## Access Compliance Report Public Rights-of-Way (Curb Ramps)

Intersection ID: 10796 Main Street: LEIGH\_AV Cross Street: PINCKNEY\_AV Location: E

ADA ID: 657BCF5ADE7D Ramp Type: Perpendicular Initial Pass/Fail: Fail Overall Compliance: No Severity Score: 21.25

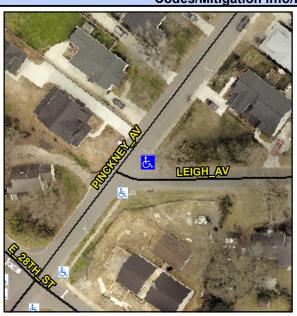
R304.5.1, R304.5.3

Field Measurements/Component Compliance					
Comp	liance Description	Data	Comp	liance Description	Data
N/A	Ramp Length (in)	23.5	Yes	Ramp Slope (%)	7.0
No	Ramp Width (in)	46.0	No	Ramp XSlope (%)	5.7
N/A	Flare Type LT	N/A	N/A	Flare Type RT	N/A
N/A	Flare Slope LT (%)	N/A	N/A	Flare Slope RT (%)	N/A
N/A	Flare Traversable LT?	N/A	N/A	Flare Traversable RT?	N/A
N/A	Landing Length (in)	N/A	N/A	DWS Provided?	N/A
N/A	Landing Width (in)	N/A	N/A	DWS Contrast?	N/A
N/A	Landing Slope (%)	N/A	N/A	DWS Length (in)	N/A
N/A	Landing X Slope (%)	N/A	N/A	DWS Full Width?	N/A
N/A	Landing Curb? (Y/N)	N/A	N/A	DWS Offset (in)	N/A
N/A	Shared Landing?	N/A			
N/A	Gutter Ponding?	N/A	N/A	Gutter Slope (%)	N/A
N/A	Gutter Lip Ht (in)	N/A	N/A	Gutter X Slope (%)	N/A
N/A	Painted X Walk1?	No	N/A	Painted X Walk2?	N/A
	X Walk 1 Direction	To SW		X Walk 2 Direction	N/A
N/A	X Walk 1 Width (in)	N/A	N/A	X Walk 2 Width (in)	N/A
	X Walk 1 Slope (%)	1.2		X Walk 2 Slope (%)	N/A

Remove & Replace Entire Ramp.
